Mosaic Fertilizer, LLC
13830 Circa Crossing Drive
Lithia, FL 33547

June 25, 2010

Re: New Wales Plant, Multifos C Kiln
DEP Project No. 1050059-066-AC

DATE: 06/17/10	NEW WALES MULTIFOS C KILN	MOSAIC FERTILIZER
EUIDs 074, 075		FLOW DIAGRAM - DUMP CHUTE OPERATION

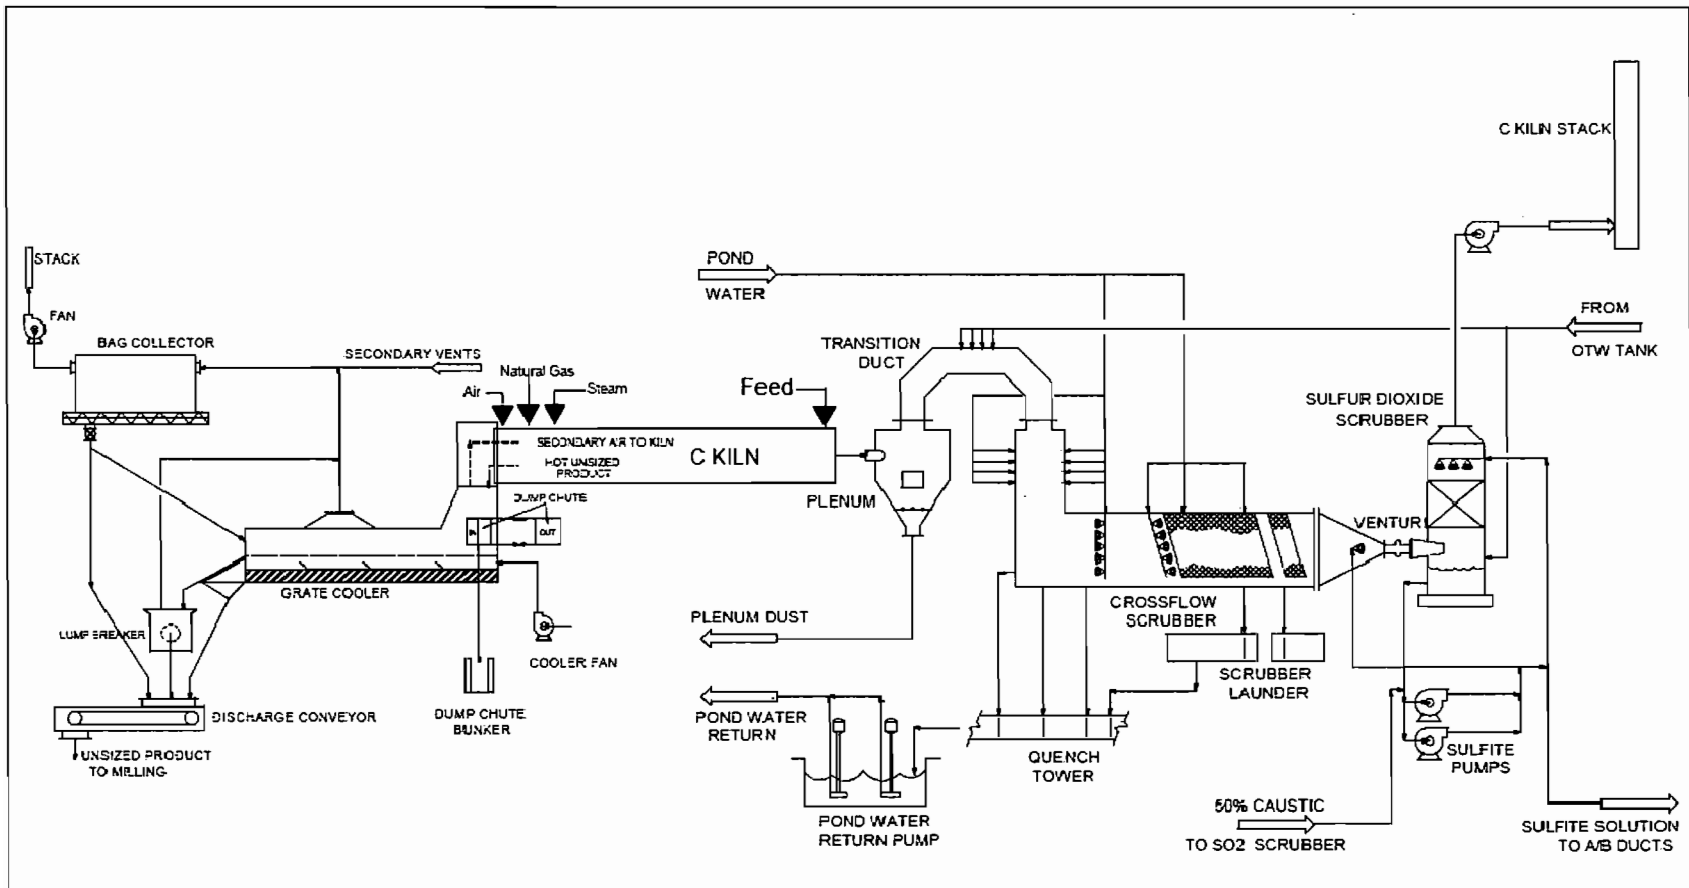
3. Please provide pictures showing the dump chute method of operations.

Pictures showing the dump chute, a process flow diagram showing its location and operation, and video clips of the dump chute operation are provided with this response. Briefly, kiln feed, essentially comprising dried phosphate rock that has been blended with soda ash and phosphoric acid in the pugmill, is fed into the kiln at one end, traverses the length of the kiln to be defluorinated and exits at the other end to enter the grate cooler. Defluorination kiln temperatures and operational control are achieved by air, natural gas and steam that are input at the exit end of the kiln. The connecting section between the kiln and the grate cooler has an opening, closed under normal operations, into which a dump chute is inserted to divert the material exiting the kiln from entering the grate cooler. The inserted dump chute thus diverts the exiting kiln material into a dump chute bunker. This dump chute alternate method of operation is used when upset conditions are encountered. As explained in the application, the flow of feed material under this upset condition is reduced from the normal approximately 10 tons per hour to about 4 tons per hour and the all other flows into the kiln are accordingly throttled but not cut off completely so as keep the kiln operating at a rate that will minimize, or even when possible obviate, the detrimental effects of thermal shock that will set in and occur if the kiln was shut down. The material collected in the dump chute bunker during this upset condition is later recycled in with the normal operation feed material when normal operations is resumed. Sketch number 1 is provided in the attachment section illustrates this dump chute operation. As shown in the sketch, with the dump chute in the 'out' position, the hot unsized product from the kiln drops down into the grate cooler and goes on to the discharge conveyor. With the dump chute in the 'in' position, the hot unsized product from the kiln is diverted away from

going into the grate cooler and goes into the dump chute bunker. The annotated pictures included show the kiln, the dump chute and the dump chute bunker, in relation to the kiln and the grate cooler. Video clips showing the dump chute in operation are also included with this submission.
